Access Compliance Report

Public Rights-of-Way

(Curb Ramps)

Intersection ID: 4575	Main Street: FRANK_VANCE_RD	Cross Street: BEATTIES_FORD_RD	Location:	N
ADA ID: E67BBB2528C1	Ramp Type: Perp	Initial Pass/Fail: Fail	Overall Compliance: No	Severity Score: 47.5

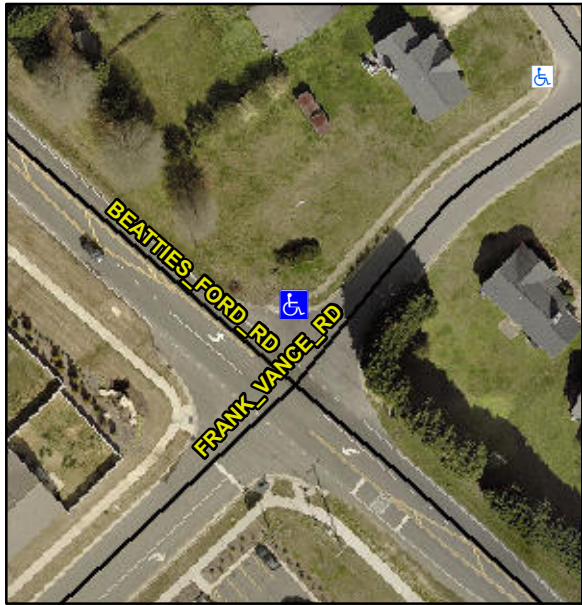
Codes/Mitigation Info/Possible Solution			Field Measurements/Component Compliance					
	Possible Solutions:		Compliance	Description	Data	Compliance	Description	Data
	Remove & Replace Entire Ramp.		N/A	Ramp Length (in)	92.0	No	Ramp Slope (%)	8.5
			No	Ramp Width (in)	30.5	Yes	Ramp XSlope (%)	2.0
			N/A	Flare Type LT	N/A	N/A	Flare Type RT	N/A
			N/A	Flare Slope LT (%)	N/A	N/A	Flare Slope RT (%)	N/A
			N/A	Flare Traversable LT?	N/A	N/A	Flare Traversable RT?	N/A
			N/A	Landing Length (in)	N/A	N/A	DWS Provided?	N/A
			N/A	Landing Width (in)	N/A	N/A	DWS Contrast?	N/A
			N/A	Landing Slope (%)	N/A	N/A	DWS Length (in)	N/A
			N/A	Landing X Slope (%)	N/A	N/A	DWS Full Width?	N/A
Surveyor Notes:			N/A	Landing Curb? (Y/N)	N/A	N/A	DWS Offset (in)	N/A
N/A			N/A	Shared Landing?	N/A			
PROW/ADA:			N/A	Gutter Ponding?	N/A	N/A	Gutter Slope (%)	N/A
Not Found, R304.5.1, R304.2.2			N/A	Gutter Lip Ht (in)	N/A	N/A	Gutter X Slope (%)	N/A

N/A	Painted X Walk1?	No	N/A	Painted X Walk2?	N/A
				X Walk 1 Direction	To SW		X Walk 2 Direction	N/A
			N/A	X Walk 1 Width (in)	N/A	N/A	X Walk 2 Width (in)	N/A
				X Walk 1 Slope (%)	0.9		X Walk 2 Slope (%)	N/A
				X Walk 1 X Slope (%)	3.0		X Walk 2 X Slope (%)	N/A
			N/A	Ramp inside XWalk1?	N/A	N/A	Ramp inside XWalk2?	N/A
				Road Slope (%)	3.0	N/A	Clear Space?	N/A
				Road X Slope (%)	0.9	N/A	Clear Space to XWalk (in)	N/A
			N/A	Any Obstructions?	N/A	N/A	Storm Grate/Utility Hazard?	N/A
				Obstruction Type			Storm Grate/Utility Type	
						N/A		N/A
						Yes	Surface Condition? (G/P)	Good
Total Cost:		\$ 1850.00
